Technical Bulletin

Bulletin No: TCH-013-004-A

THOMAS BUILT - ANTILOCK CONTROLLER GROUNDING

Figure 1 Locating the Voltage Box

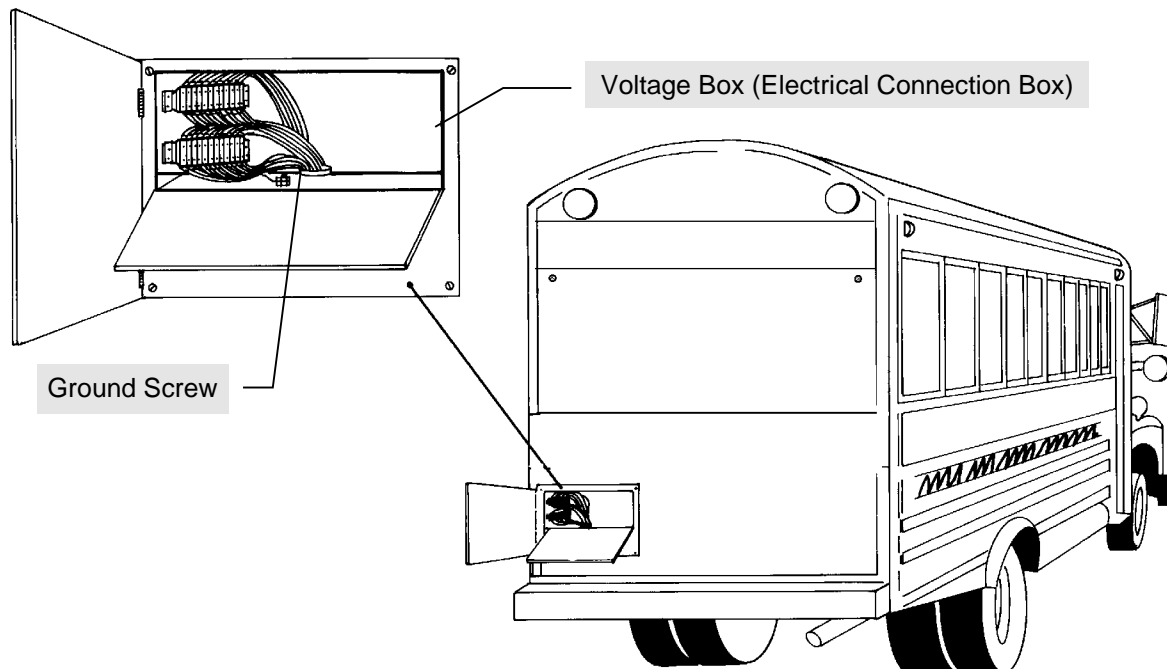
1. Lift the access panel at the rear of the coach and locate the voltage box on the driver's side of the compartment (see figure 1).

Figure 2 Removing Spade Connector From Bus Bar

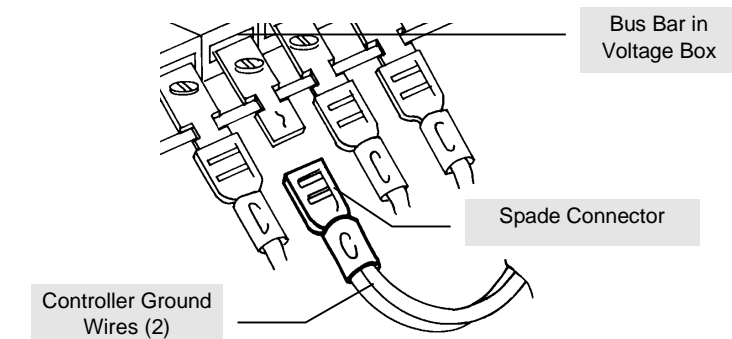
2. Locate the spade connector, with two ground wires on it (generally on the second terminal of the lower bus bar) and remove the spade connector from the bus bar (see figure 2). Verify that vehicle power to the AntiLock controller is off by noting that the green LED on the AntiLock Controller is no longer illuminated even though vehicle power is on.

Figure 3 Cutting Spade terminal from ground wires

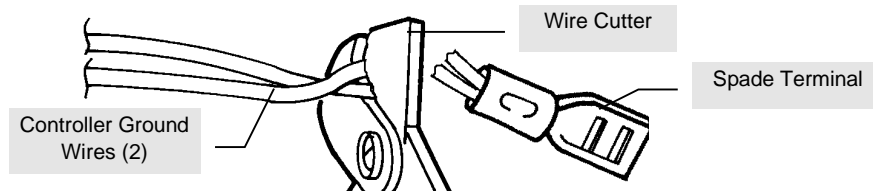
3. Cut the spade connector from the two ground wires and strip 1/4" of insulation from the wires (see figure 3).

Figure 5 Installing Ring terminal ground screw

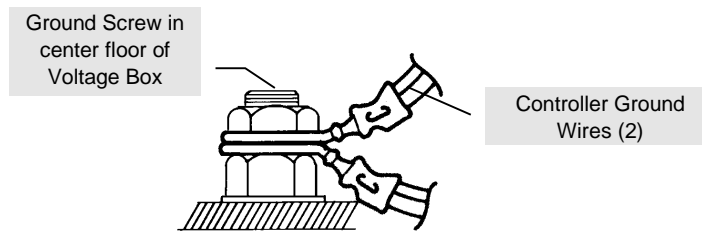
5. Reroute the two ground wires (with ring terminal installed) to the ground screw on the center of the floor in the voltage box and bolt the ring terminal to this ground point (see figures 1 & 5). The green LED on the AntiLock controller should now be illuminated when the vehicle is "powered up".
6. Perform the Antilock "Initial Start-Up" Procedure.
